6-21-0566 (Ovard HOA) July 13, 2023

**CORRESPONDENCE**

Re: Item Th11a, Application No. 6-21-0566, 1601 South Pacific Street, Oceanside, San Diego County

The red line traces concrete grouting

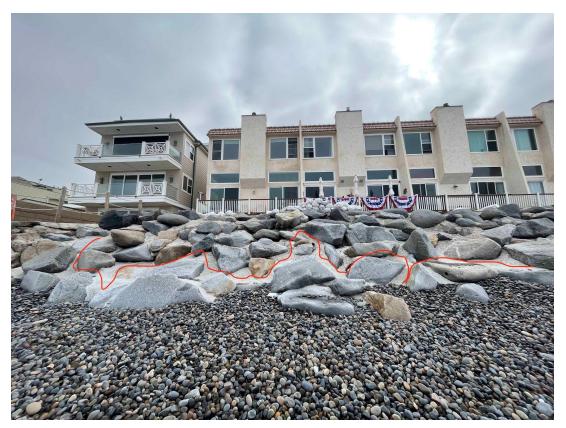
We appreciate the additional special conditions re: the unpermitted stairways and concrete at this property, including the Construction Documentation Plan which requires photo and/or video evidence that the stairways and concrete grouting are properly removed (Special Condition 2). Similarly, the Long-Term Monitoring Program requires the applicant to remove any additional concrete grouting that becomes exposed or dislodged in the future (Special Condition 3f). This is important because a sizable portion of the revetment is currently buried under sand and cobbles, making it impossible to corroborate the applicant's claim that concrete grouting is only present on the upper portion of the revetment. For example, the following photo from July 6, 2023, shows the presence of concrete grouting at the lowest visible areas of the revetment:
